Corporate Environmental Program
General Electric Company
100 Woodlawn Ave., Pittsfield, MA 01201

August 12, 1999

Re: Pittsfield/Housatonic River Site,
On-Plant Consolidation Areas -
Addendum to June 1999 Detailed Work Plan

FIGURE
1

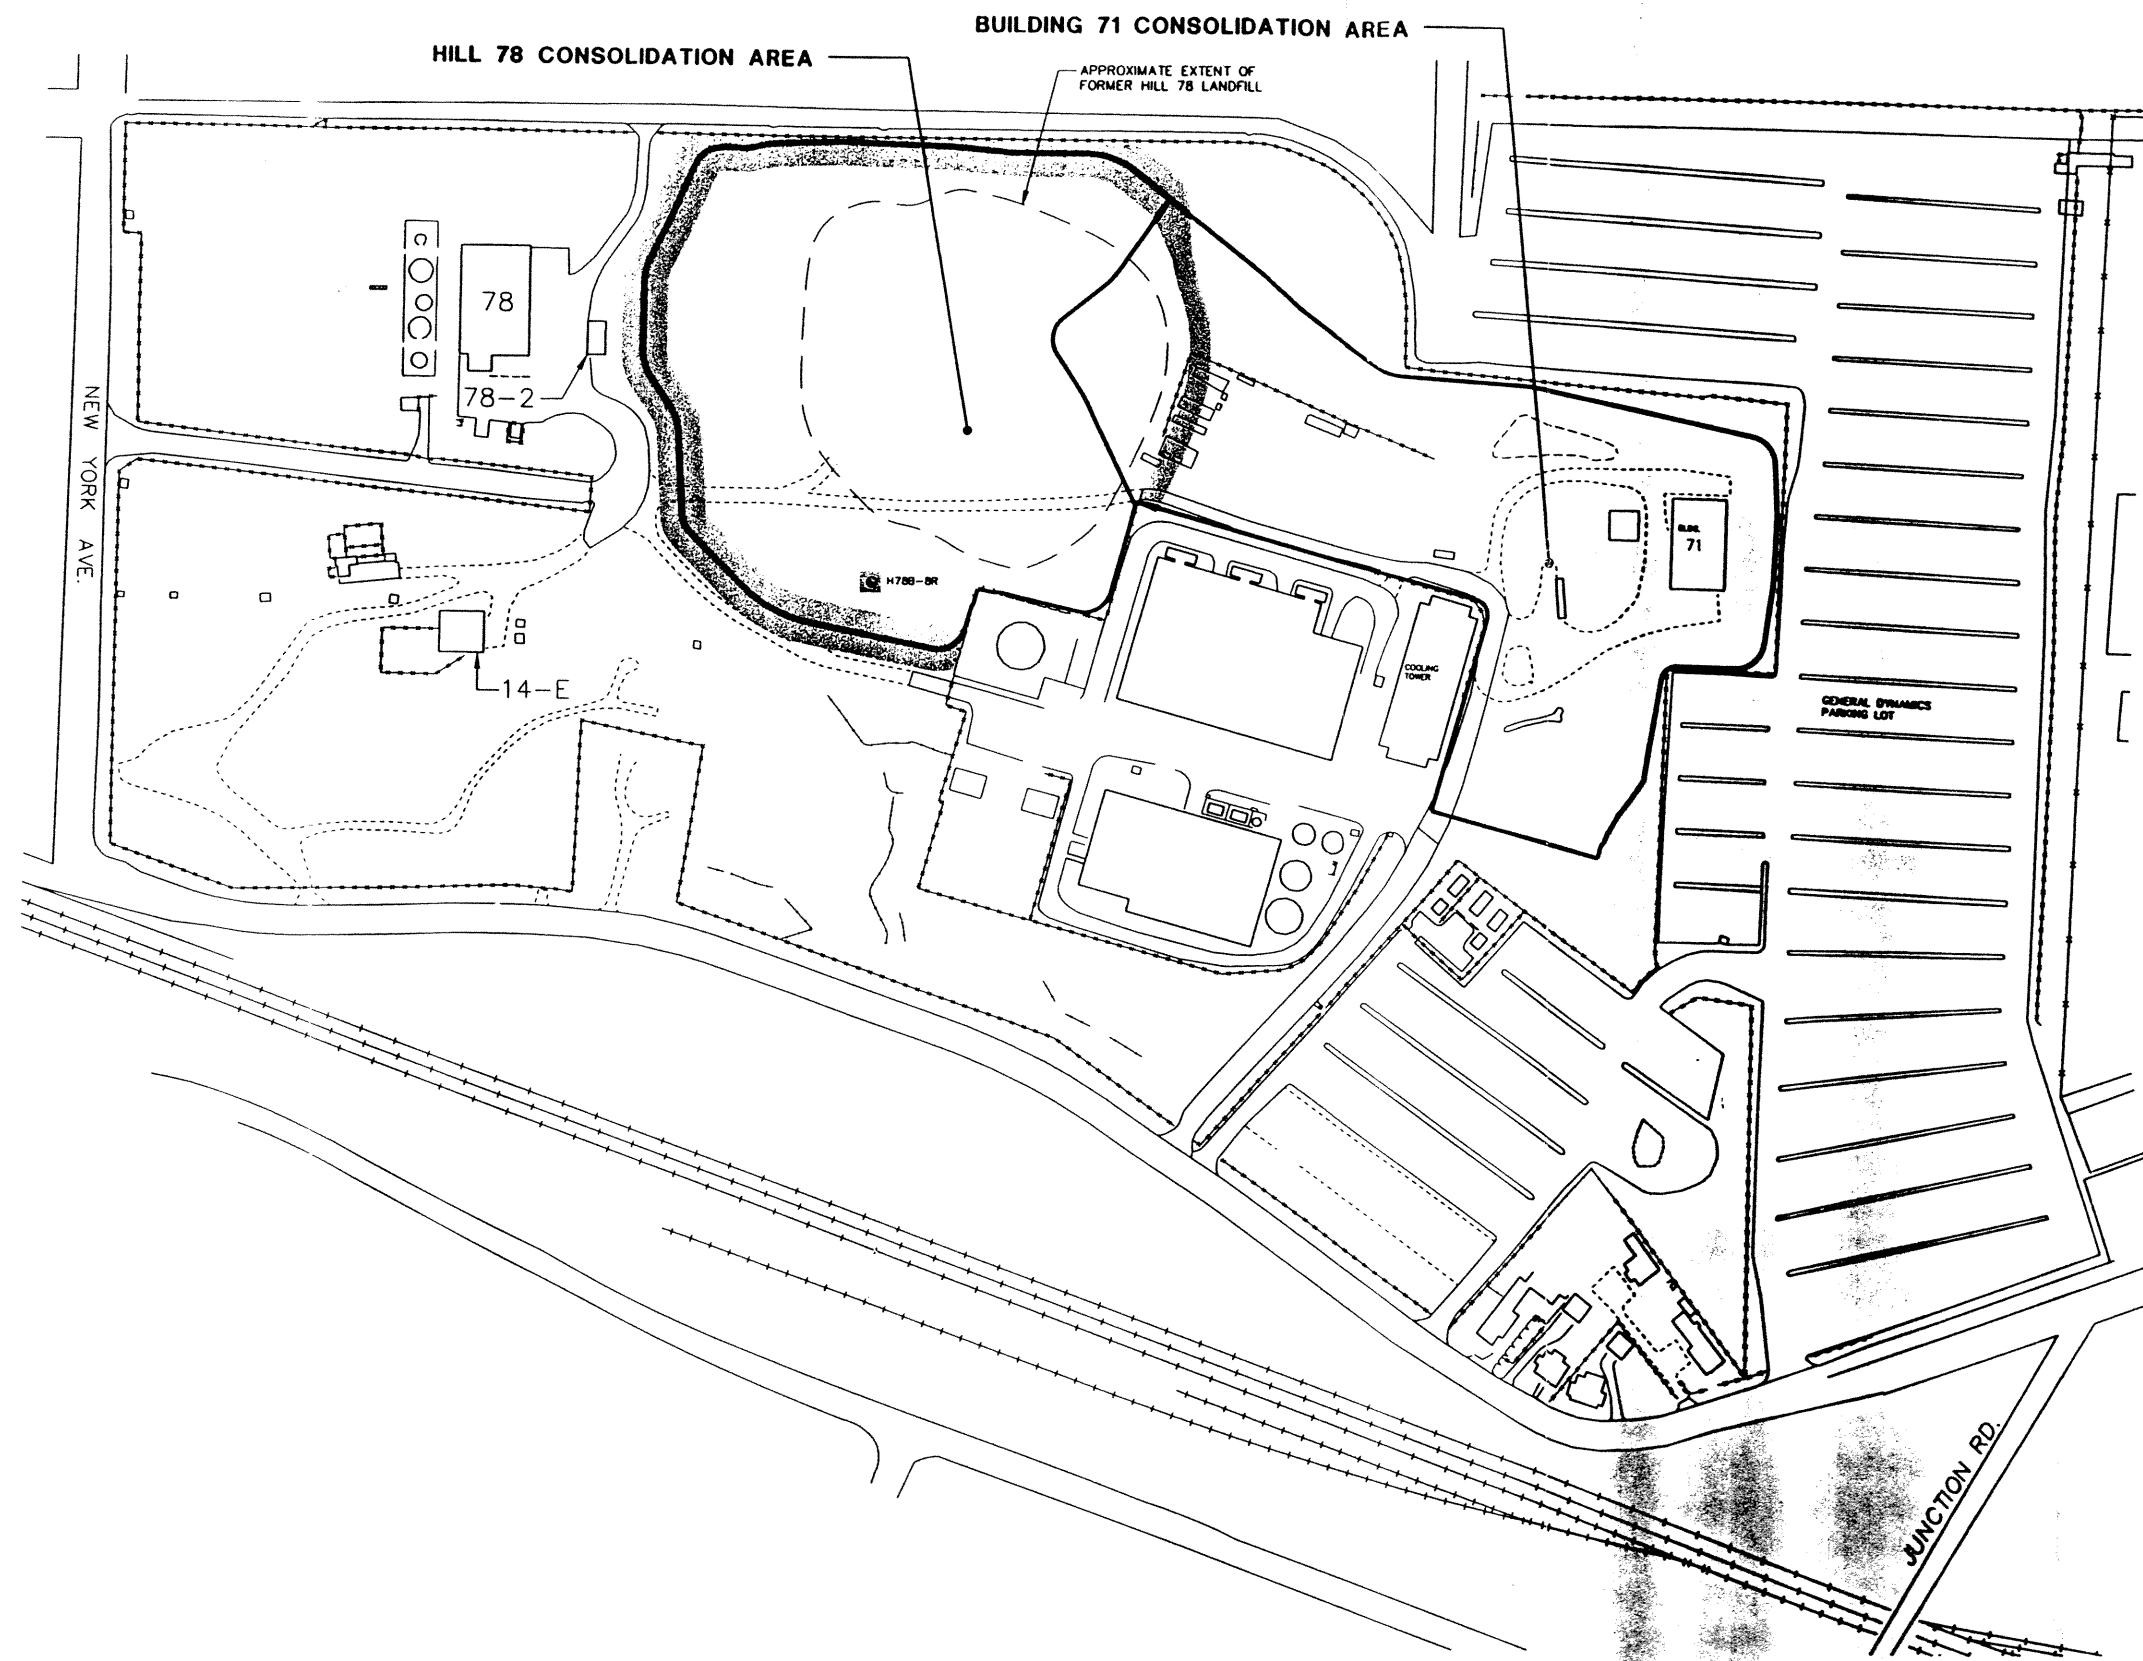
Figure 1: The Site Location Map does not identify the facility per the definition of the CD.

A revised Figure 1 is included as Attachment J to this Addendum.
